UNIVERSITY OF CALIFORNIA, IRVINE

**Re: Docket 50-326 Relicense, RAI dated April 5, 2011 (TAC ME1579),  
extension granted to July 1<sup>st</sup>, 2011.**

UCI RESPONSE TO:  
OFFICE OF NUCLEAR REACTOR REGULATION  
REQUEST FOR ADDITIONAL INFORMATION  
UNIVERSITY OF CALIFORNIA IRVINE NUCLEAR REACTOR FACILITY  
LICENSE NO. R-116  
DOCKET NO. 50-326

Fig 4-2 Reactor Aluminum Tank Liner

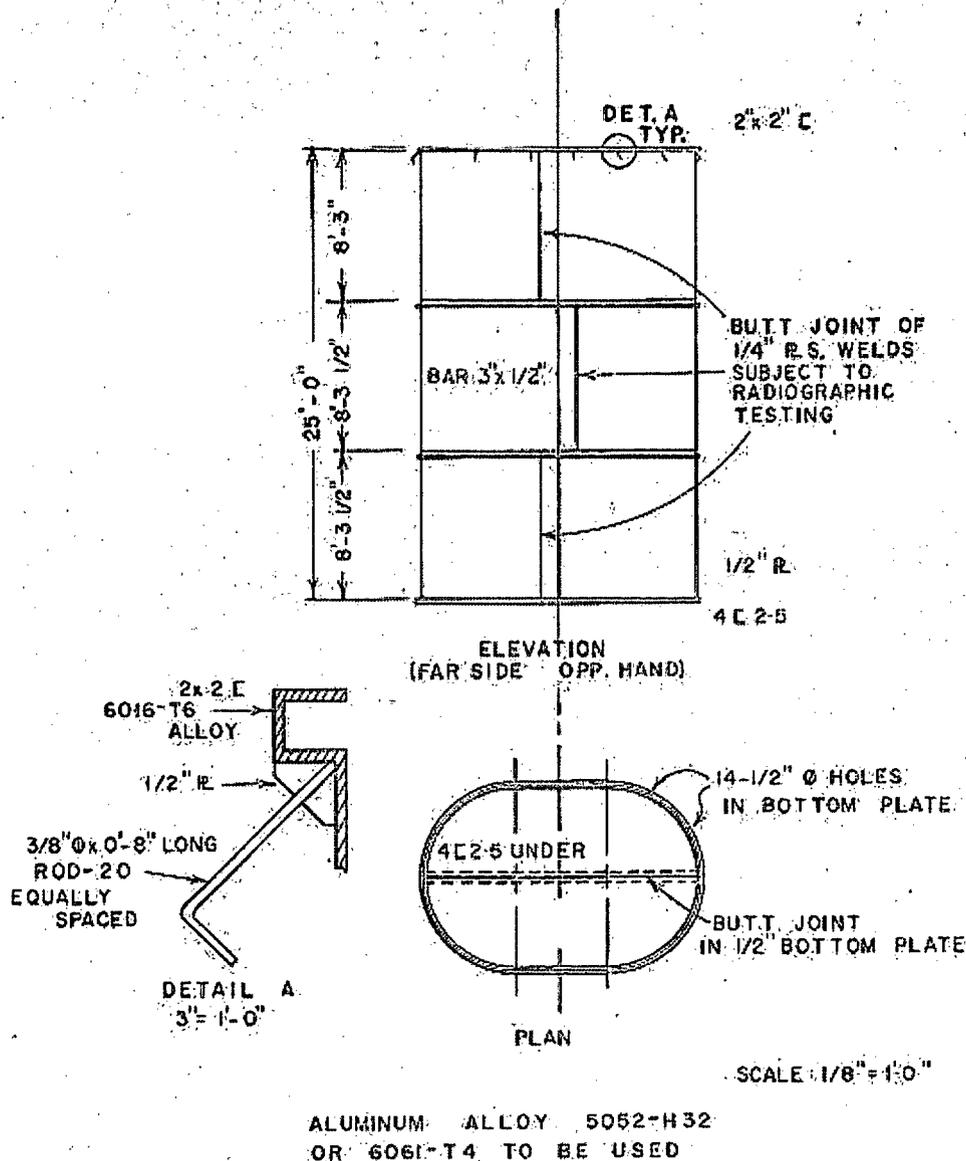
- (3) NUREG 1537, Chapter 4, "Reactor Tank and Pool," recommends that consideration be given to methods for assessing and preventing corrosion to the tank exterior. From the NRC's Inspection Report dated January 13, 2011, it is noted that ground water from rain and irrigation has been observed in fuel storage pits and in monitoring wells in the in- ground spaces around the exterior of the reactor tank. Please provide a discussion describing the impact to the reactor tank liner and other structures, as applicable, associated with this groundwater incursion. Since this groundwater incursion may cause corrosion, in your discussion, please describe how corrosion can be detected for the reactor tank and other structures, as applicable. Please include a discussion regarding detection of leakage from the reactor tank.

*No evidence to this date of corrosion to the reactor pool tank from the outside has been detected, nor corrosion to other structures beyond that by incursion into the storage pits described to NRC in various communications several years ago. The tank is protected by impermeable wrapping as described in our SAR. However in order to mitigate the possibility of corrosion induced by the unanticipated ground water from the outside, the facility has recently installed a permanent pump and level measuring sensor in the closest monitoring well with the goal of maintaining the ground water level surrounding the pool tank to below the level of the concrete tank. This is more fully described in the revised SAR section 4.2 appended in full below.*

The pool consists of an aluminum tank liner 10 ft wide by 15 ft long and 25 ft deep (Fig. 4-2), 1/4 inch thick on the sides and 1/2 inch thick on the bottom supported by reinforced concrete. At the core end, 2 ft 6 in of concrete surround the liner and 4 ft 6 in of concrete are below the liner to provide support and reduce soil activation (Fig. 4-3).
